UNITED STATES PATENT AND TRADEMARK OFFICE

APPLICATION NO.	FILING DATE	FIRST NAMED INVENTOR	ATTORNEY DOCKET NO.	CONFIRMATION NO.
10/714,336	11/13/2003	Kenny Chang	JCLA11475	4087
23900	7590	10/03/2005	EXAMINER	
J C PATENTS, INC. 4 VENTURE, SUITE 250 IRVINE, CA 92618			ARENA, ANDREW OWENS	
			ART UNIT	PAPER NUMBER
			2811

Office Action Summary	Application No. 10/714,336	Applicant(s) CHANG ET AL.	
	Examiner Andrew O. Arena	Art Unit 2811

DETAILED ACTION***Claim Rejections - 35 USC § 103***

**FIG. 6**

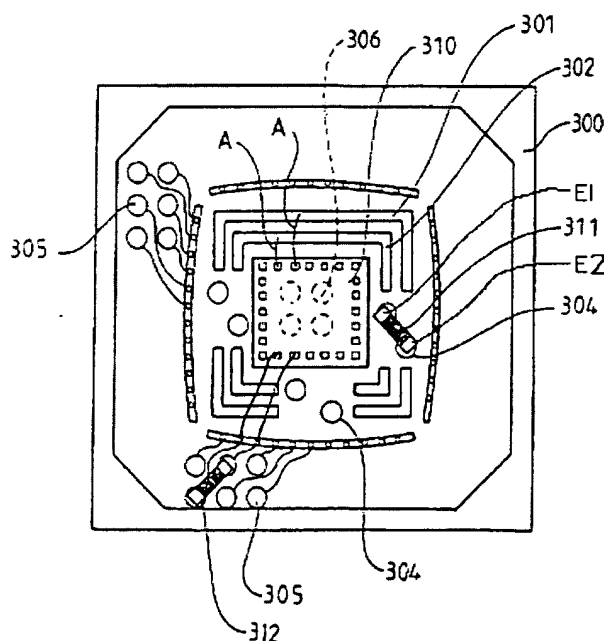
2. Claims 20-23 are rejected under 35 U.S.C. 103(a) as being unpatentable over Tao et al. (US 6,316,828) - hereinafter Tao - in view of Stearns et al. (US 5,895,967) – hereinafter Stearns – further in view of Yamaura et al. (US 6,831,360) – hereinafter Yamaura.
3. Examiner has attached a copy of Tao Fig. 6 to which has been added two reference numerals (E1, E2) used for clarity throughout this rejection.

4. Regarding claim 20, Tao discloses (Fig. 6) a package substrate (300; col 3 ln 41) adapted to carry a die (310; col 3 ln 46-48) of a wire bonding type (A; col 3 ln 37-38), the package substrate at least comprising:

a substrate (300; col 3 ln 41) having a surface, a power pad (301; col 3 ln 45-46) and a ground pad (302; col 3 ln 46), wherein the surface of the substrate having a die bonding area (310; col 3 ln 46), the power pad and the ground pad disposed outside the die bonding area;

at least one passive component (311; col 3 ln 42 – see 311 in Fig 5) disposed between the power pad and the ground pad (clear in Fig 6), the passive component having at least two electrodes (E1, E2) which are connected to the power pad and the ground pad (col 3 ln 44-46) respectively; and
